STATE OF NORTH CAROLINA
DEPARTMENT OF TRANSPORTATION

May 1, 2020

Subject: Revised Modification Request for the Section 404 Individual Permit and Section 401 Water Quality Certification for the proposed Havelock Bypass in Craven County. TIP No. R-1015. Debit \$ 570 from WBS 34360.1.2

PROJECT REFERENCE NO. R-1015		SHEET NO. NE-03
RW SHEET NO. ROADWAY DESIGN ENGINEER		HYDRAULICS ENGINEER
DOCUMENT NOT CONSIDERED FINAL UNLESS ALL SIGNATURES COMPLETED		
		4750 FALLS OF NEUSE ROAD, SUITE 300 RALEIGH, NORTH CAROLINA 27609 919 881-4825 VOICE 919 881-4825 FAX NC License NO. F-0105

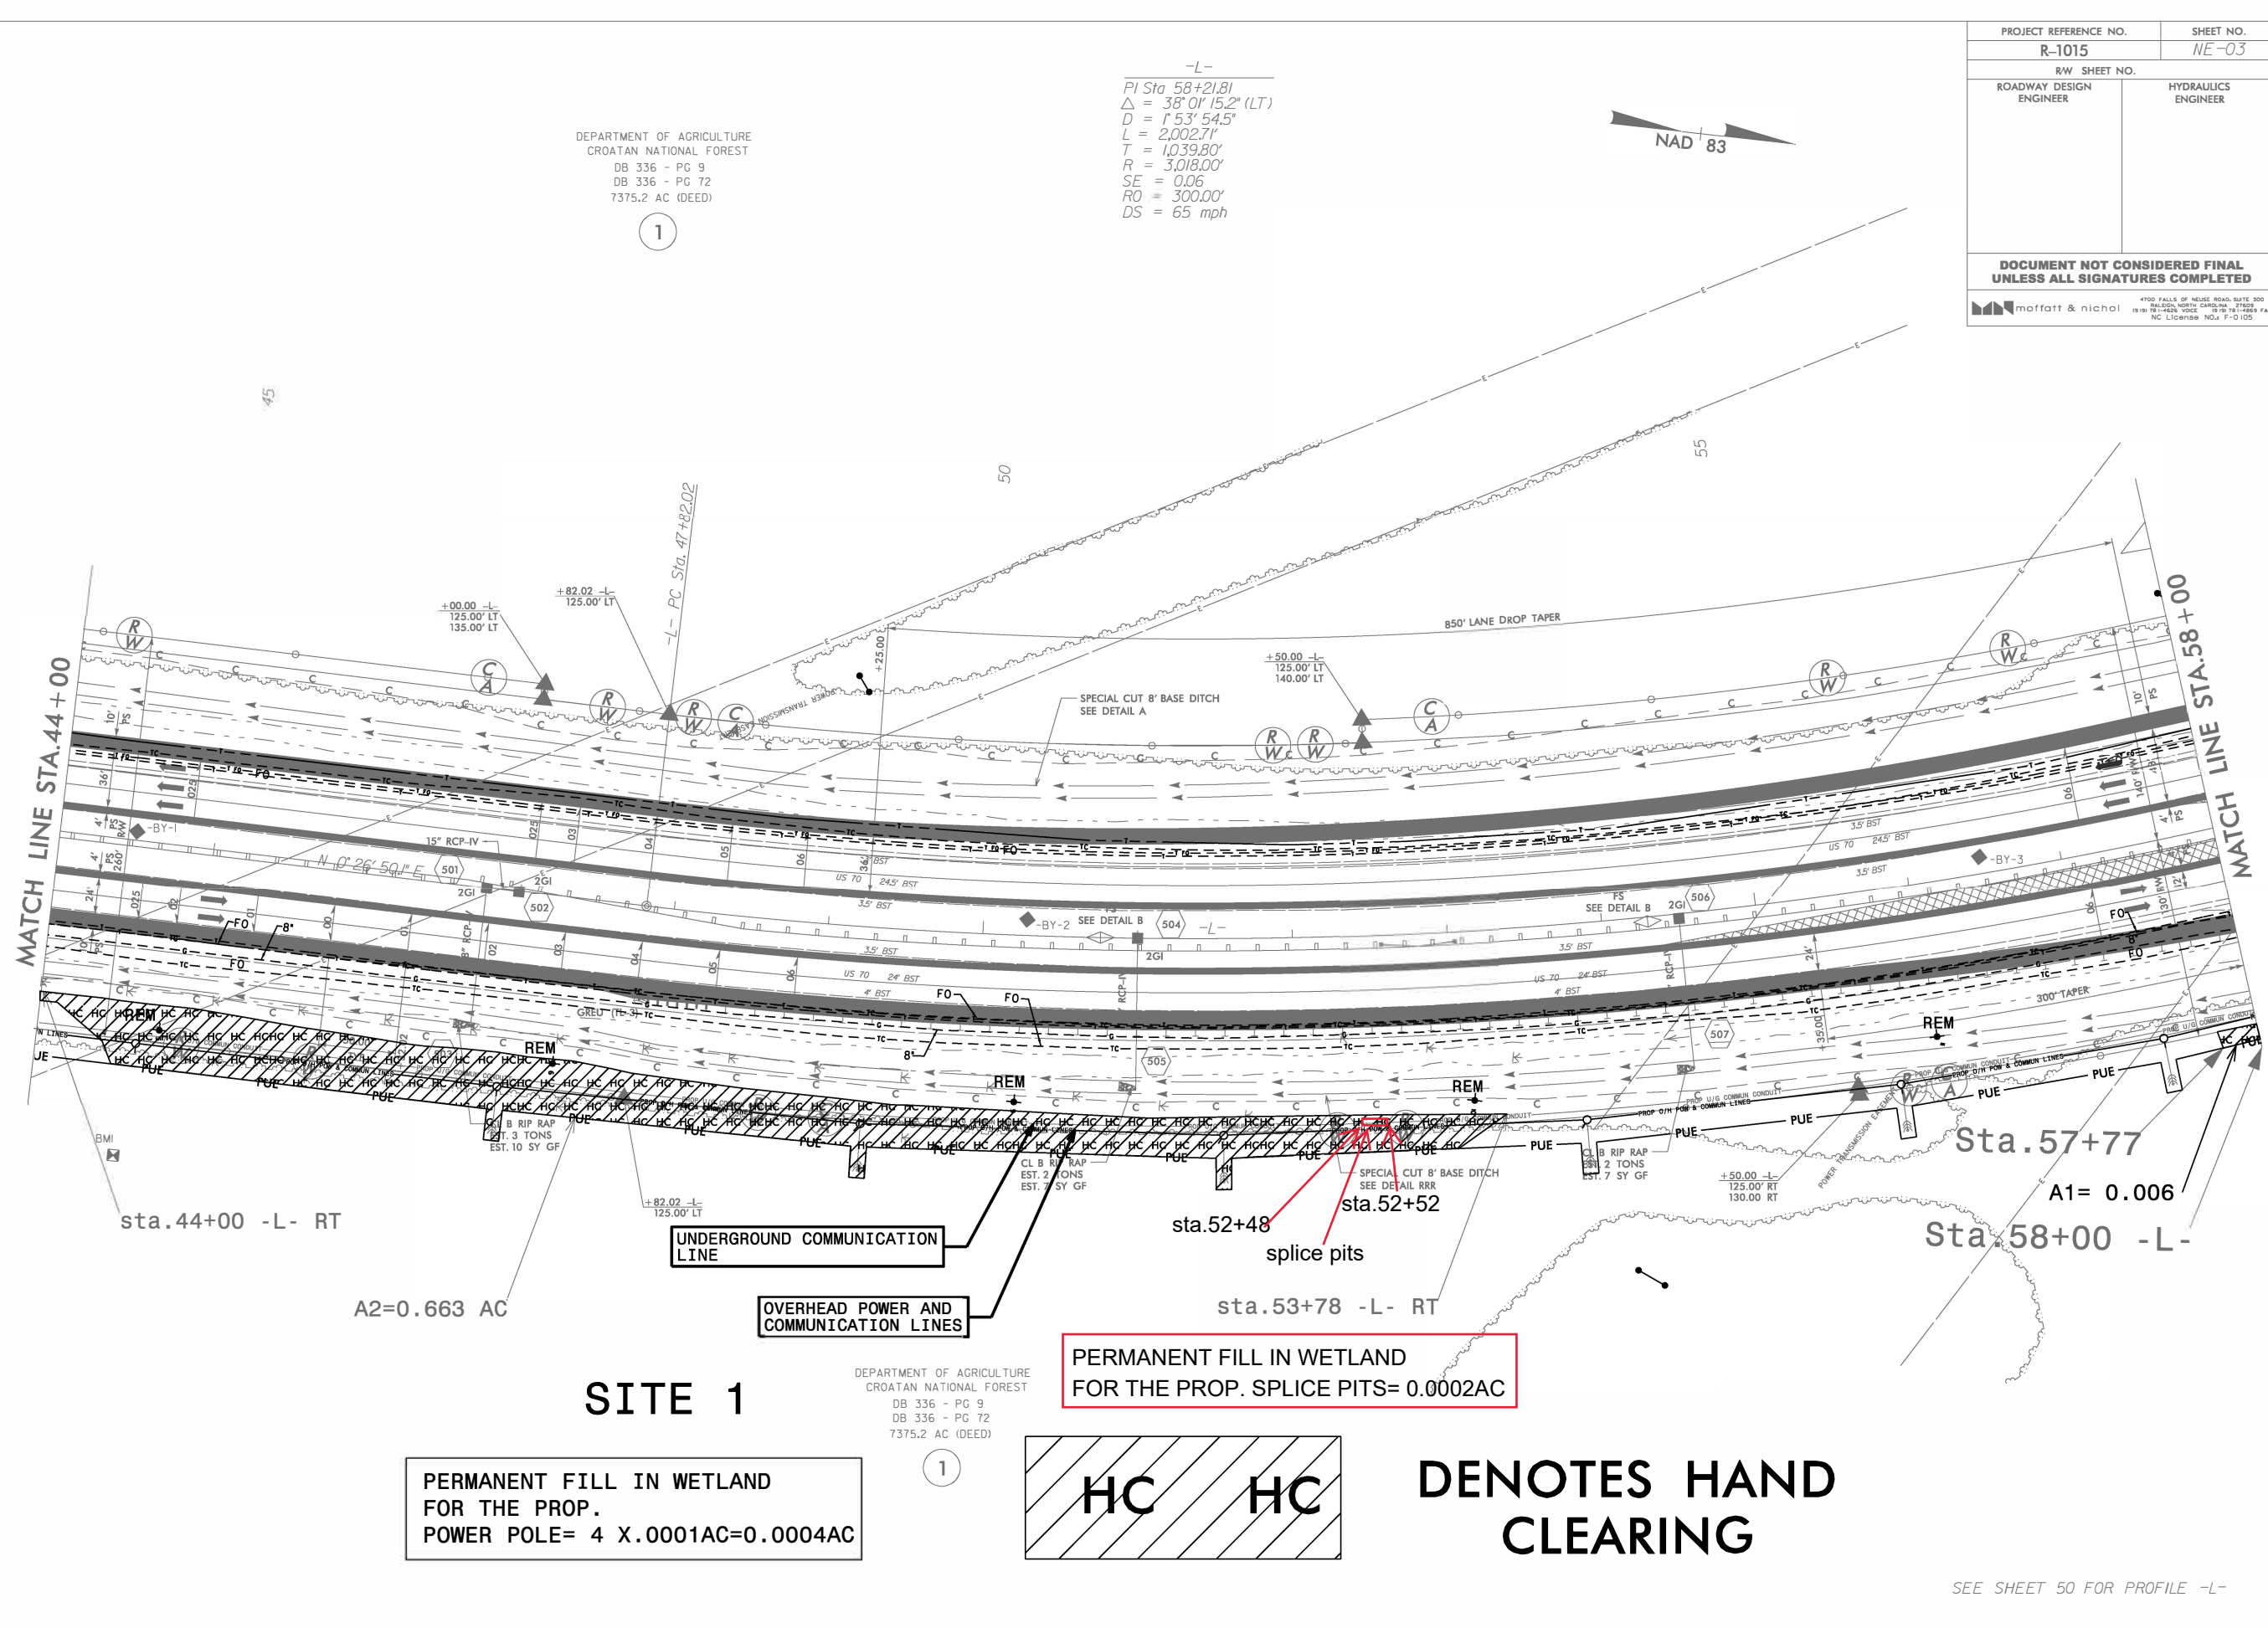
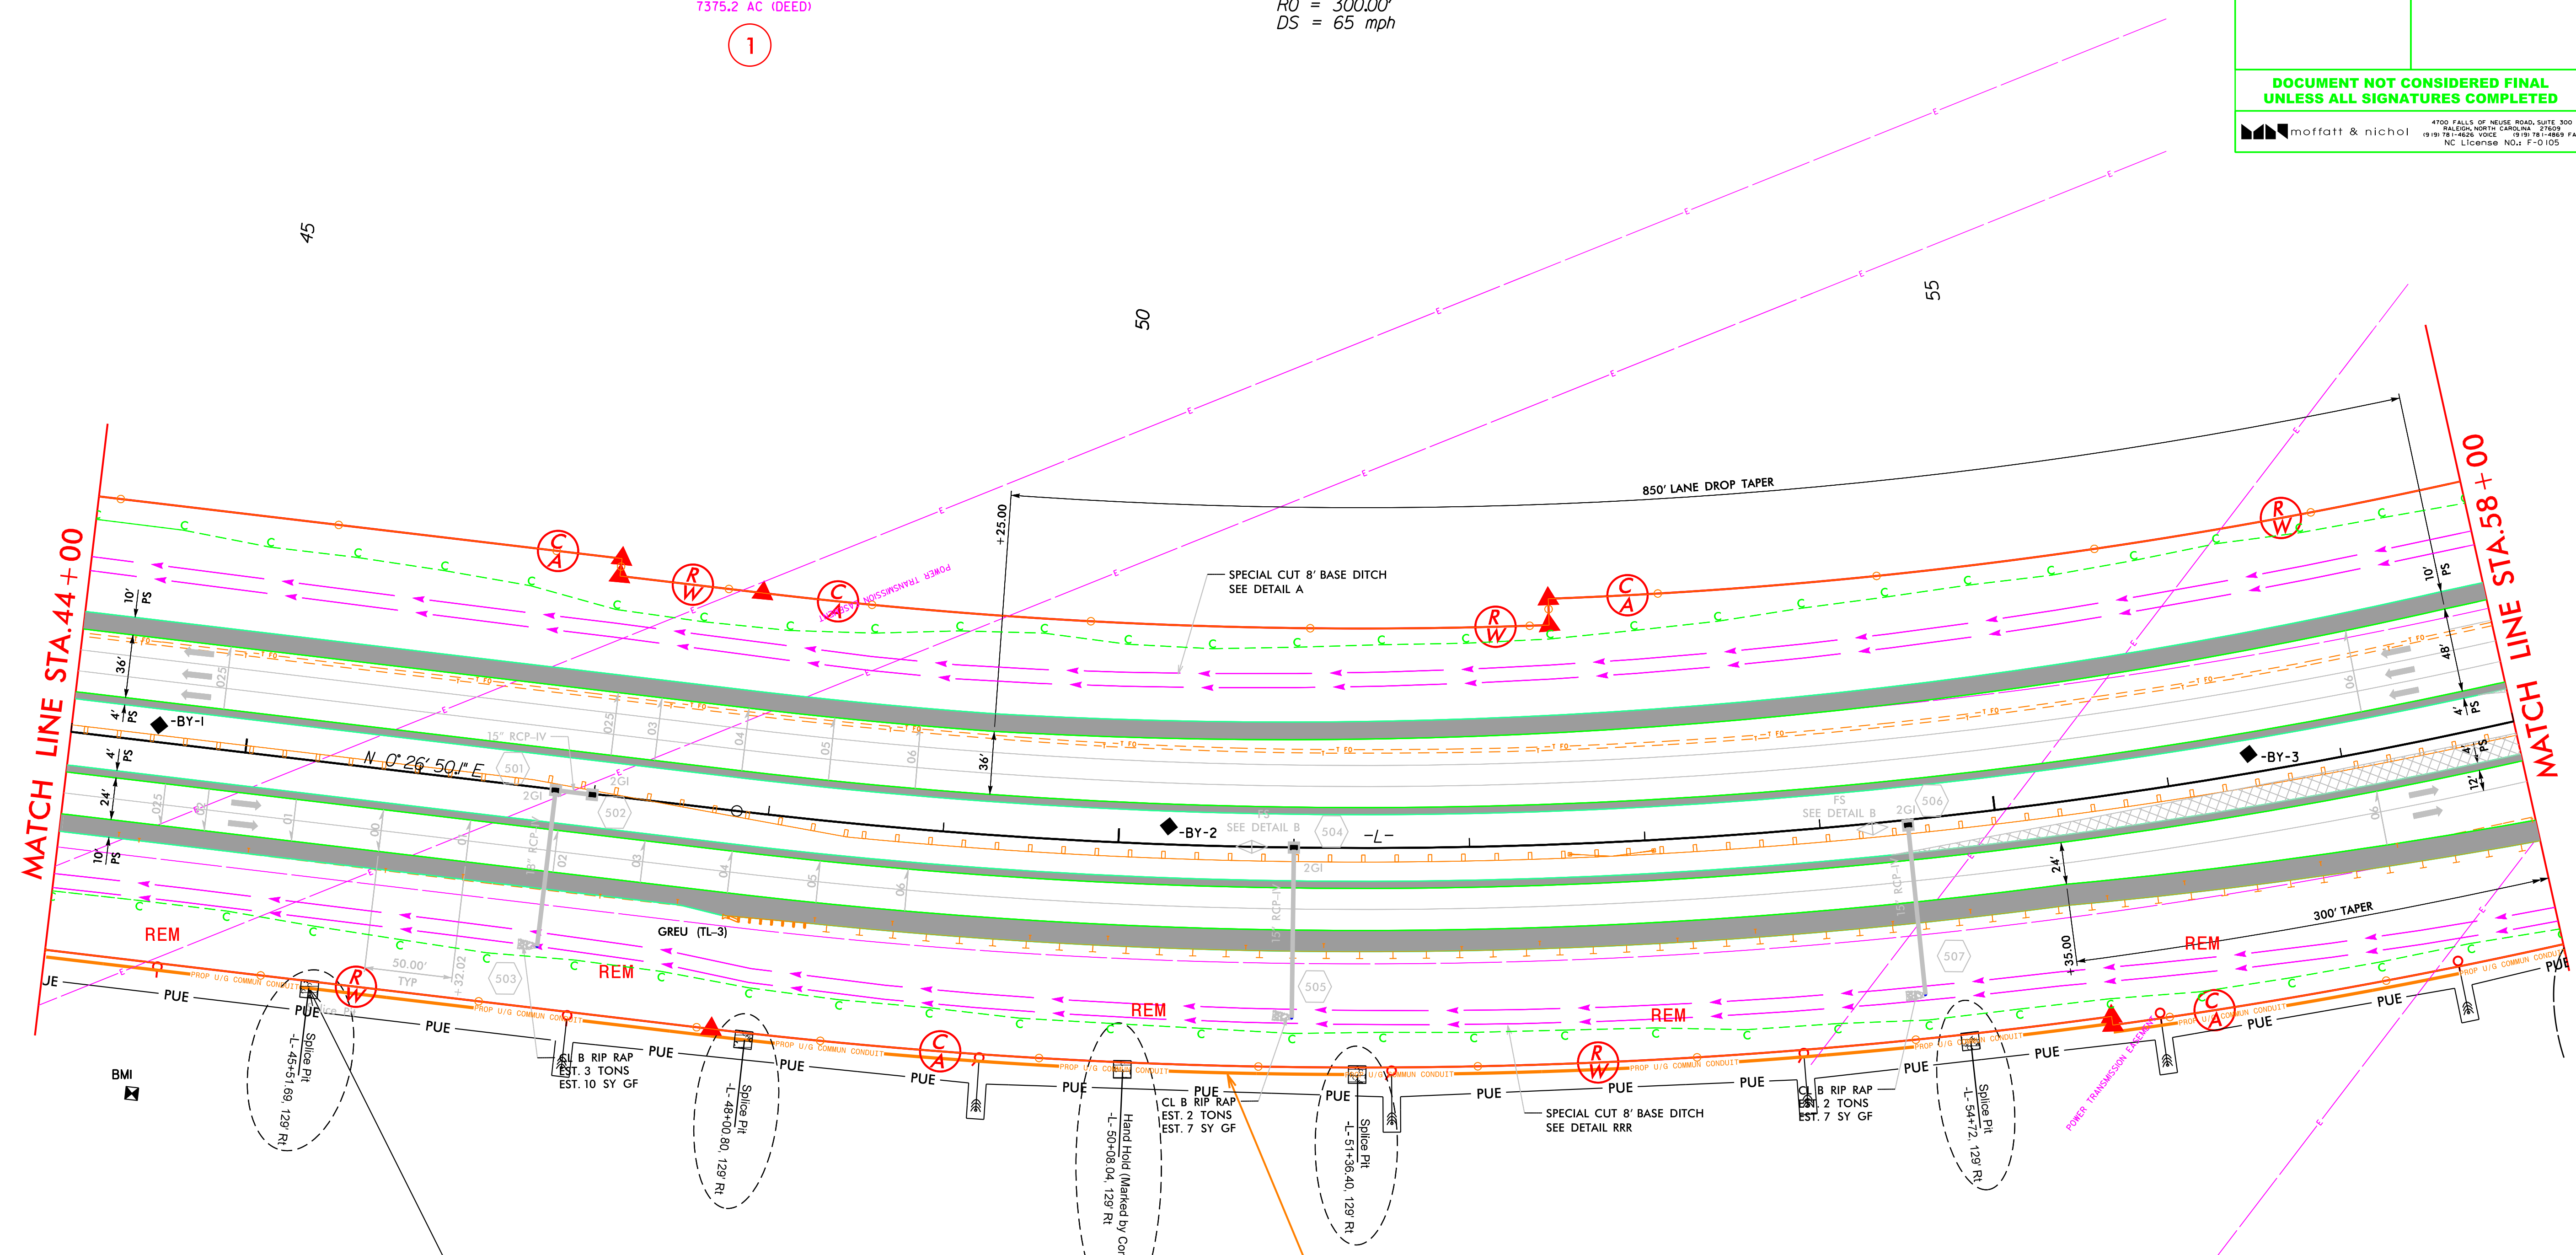
- Total permanent impact from hydraulics and roadway changes increased by 0.03 acre.
- Additional sheets have been prepared for the underground utility which requires additional impacts in wetland Sites 1, 2 and 3. The permit drawings showed underground utilities through these sections, but with no splice pits or hand holes, which are required. These supplemental drawings were revised by Division 2 to show the permanent hand holes and temporary splice pits with the total impacts required. Impacts shown on the supplemental permit drawings are as follows:

- = NE-03 (Site 1), 409 s.f. for splice pits and 15 s.f. for hand holes
 - = NE-04 (Site 2), 518 s.f. for splice pits and 30 s.f. for hand holes
 - = NE-05 (Site 3), 600 s.f. for splice pits and 30 s.f. for hand holes

- = Additional total impacts needed = 1,602 s.f. (0.037 acre) of excavation and handclearing for bore splice pits and hand holes. Additional coordination with Division 2 staff indicated this work should be counted as permanent impacts. Five utility impact sheets and the utility impact summary sheet have been updated. These three additions can be seen listed at the bottom of the site list as excavation impacts.
